Objection from Friends of Lye Valley, 11.01.2021

20/00463/FUL 2 Dynham Place Oxford Oxfordshire **OX3 7NL**

Erection of 2 x 3-bed semi detached dwellinghouses (Use Class C3).

- 1. Stantec's Supplementary Technical Note, Job No 45340, Note No 001, dated 2 December 2020, re Stantec Hydrogeological Impact Assessment and Surface Water Management Plan (Report reference: 45340/5003/R001)**
- 2. Stantec's Technical Note – Surface Water Flood Risk, Job No 45340, Note No 002, dated 2 December 2020**

'MITIGATION AND ENHANCEMENT OPTIONS - SUMMARY

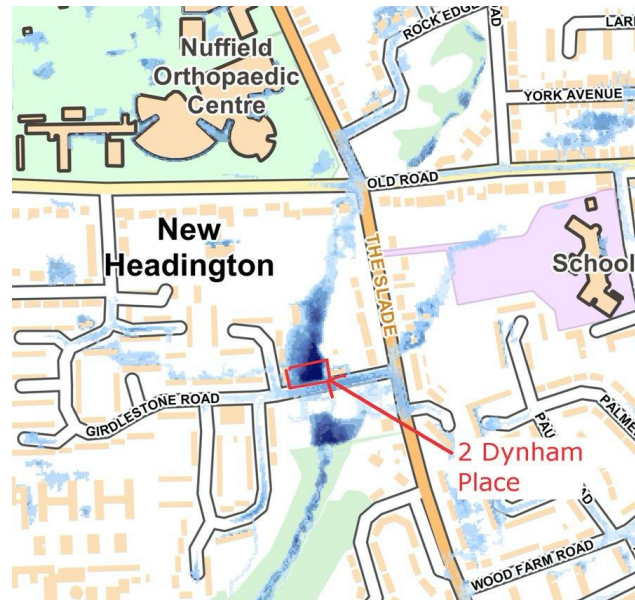
Groundwater protection zones are not fully mitigated by the use of SUDS

therefore development within these areas must be restricted or eliminated'
